Pre-bid Queries and Answer

Design, Supply, Installation, Testing and Commissioning of 132 kV Double Circuit Transmission Line and Substation Bay Extension on Turnkey Basis Tender Ref: PUR-011(EPC/TL132kV/OTM)/2022-2023, Date: 10.01.2023

- A KEC International Limited
- B Confidence Infrastructure Ltd

Figure 1 Determination of Depth of Fixity

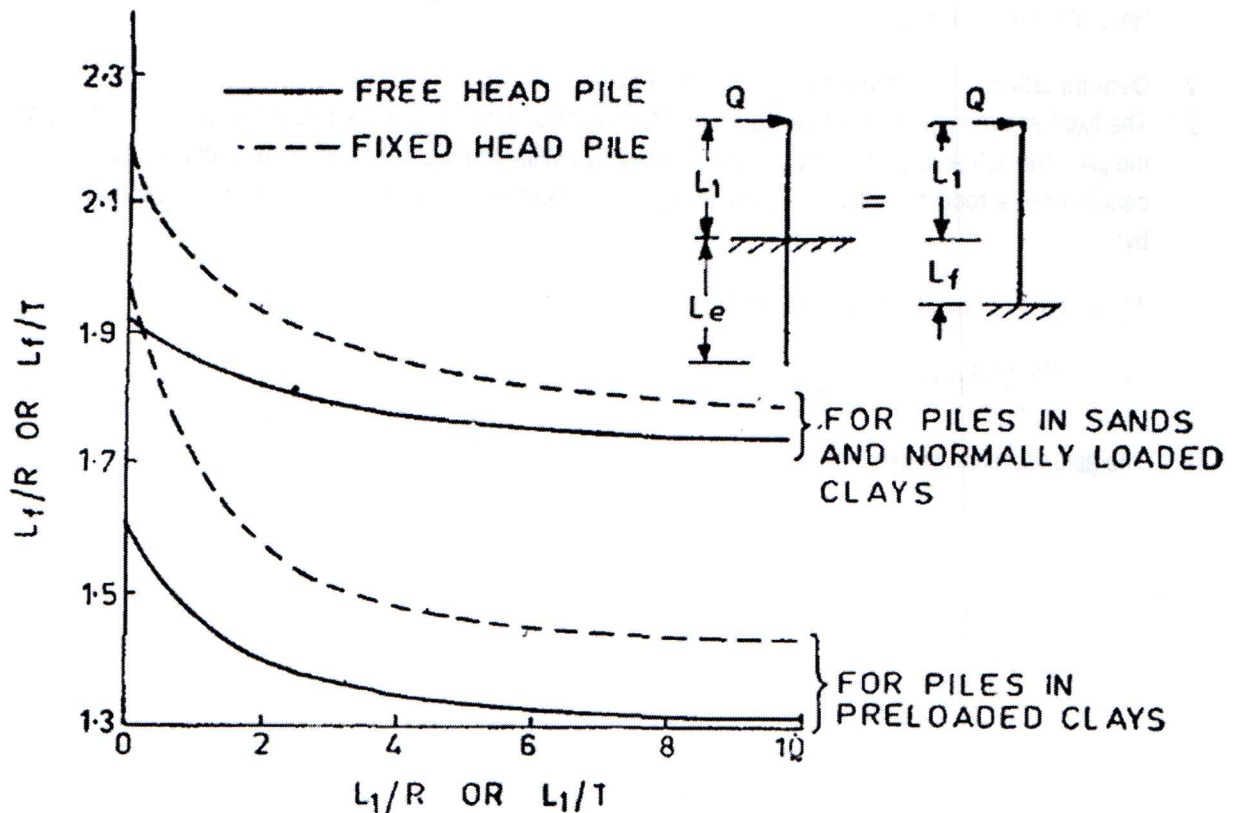
S.No.	Volume	Tender Section/Clause No.	Queries of Bidder	RPCL Reply
46			For Bored cast in situ pile design, no specific design criterias like fixicity depth, subgrade reaction for different soil category have been mentioned. So kindly clarify whether IS 2911 CODE can be followed for this or not	Tender provision will prevail. For Fixicity depth see Appendix-“AB” .
47	Volume 1	Tower Type	The Tower type given in the price schedule is 1D10, But in page 272, the foundation reaction provided is for 1D1, Kindly clarify both the tower type are same or not	1D1 and 1D10 both are same.
48	Volume 2 Part 01	22.4/ Typical Drawings	The pile type used here is RC spin Type. Kindly clarify the same.	Drawing shared in the tender document are typical drawings, types of foundations shall be decided during detailed engineering subject to approval of RPCL/PGCB.

- 1.1 The long flexible pile, fully or partially embedded, is treated as a cantilever fixed at some depth below the ground level (see Fig. 1)
- 1.2 Determine the depth of fixity and hence the equivalent length of the cantilever using the plots given in Fig. 1.

Where $T = \left(\frac{EI}{K_1}\right)^{\frac{1}{5}}$

(k_1 is a constants given in Tables 1 below, E is the Young's modulus of the pile material in kg/cm^2 and I is the moment of inertia of the pile cross-section in cm^4).

Note: Fig. 1 is valid for long flexible piles where the embedded length L_e is $\geq 4R$ or $4T$.

K_1 is the constant of modulus of horizontal subgrade reaction, Values of k_1 are given below

Soil Category	Value of constant k1 Kg/cm ³
Soil Category 2	1.00
Soil Category 3	0.525
Soil Category 4	0.146
